**REQUEST FOR PROPOSAL
TRAIL DESIGN AND EXPANSION PROJECT
SUMMER VILLAGE OF WAIPAROUS**

ADDENDUM 1

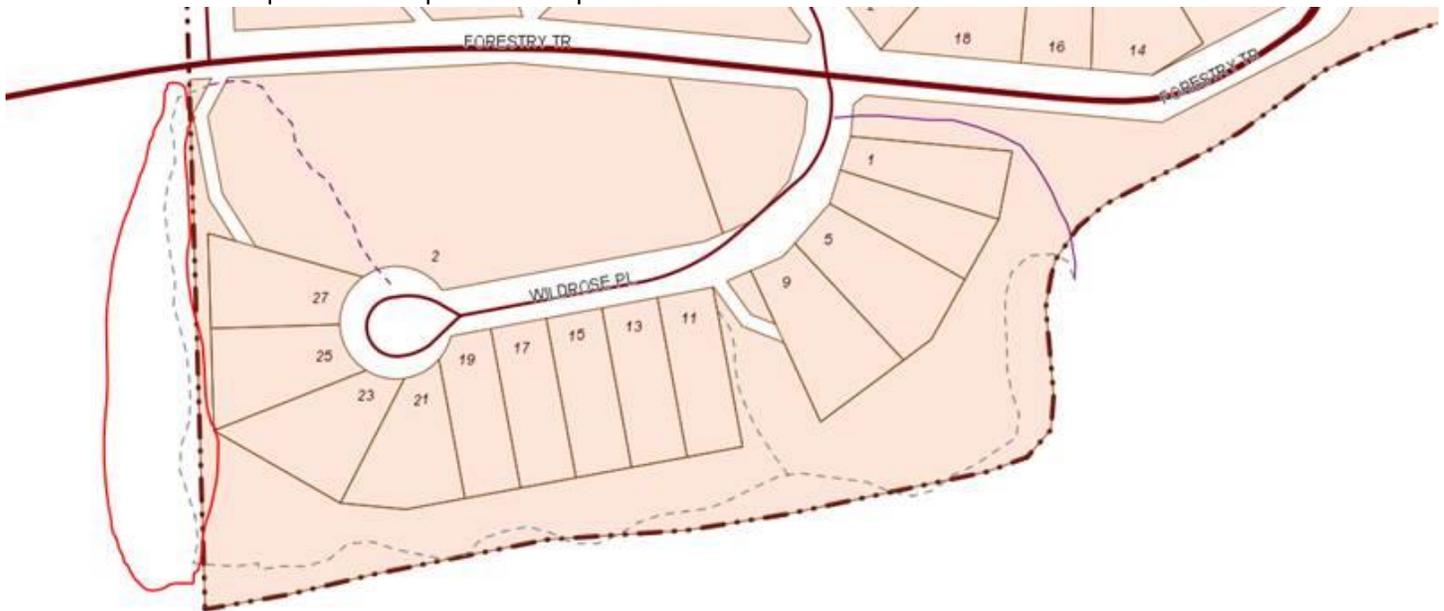
- b. Is there flexibility to re-route these trails to avoid a fall line trail on a steep slope? For instance, the trail on the west side of the river, just north of the existing bridge is shown descending to the river elevation in a fall line manner as shown in the red circle in the image below.

There is some flexibility. Council is open to all suggestions with good rational.

Appendix A

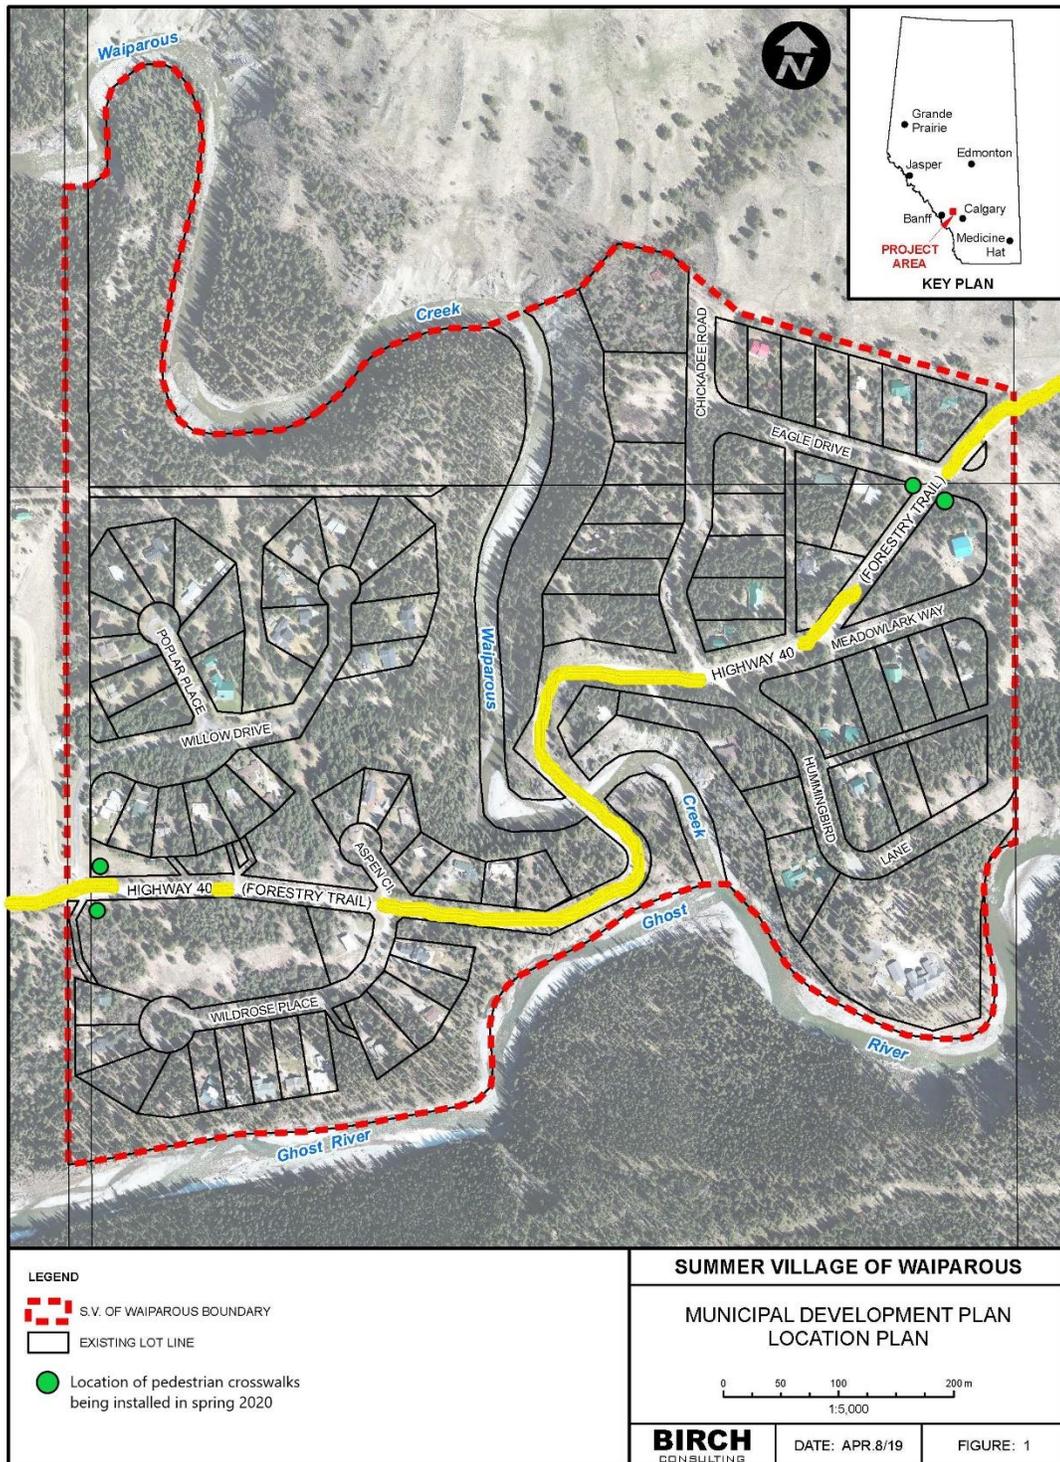
1. Can you please tell us the location of the 2 pedestrian crosswalks that will be installed in the spring 2020?

6. Can you provide drawing or sketch of the two proposed pedestrian crosswalk that will be installed this year?

- a. Section 3.1, bullet point 1a. states "Connection to the 2 pedestrian crosswalks being installed in the spring of 2020 to the trail system". Where are these crosswalks located?

Appendix A shows the locations of the 2 crosswalks that will be installed in the spring of 2020.

See Appendix A

See Appendix A

Final approved locations of pedestrian crosswalks over Highway 40 in the Summer Village of Waiparous.
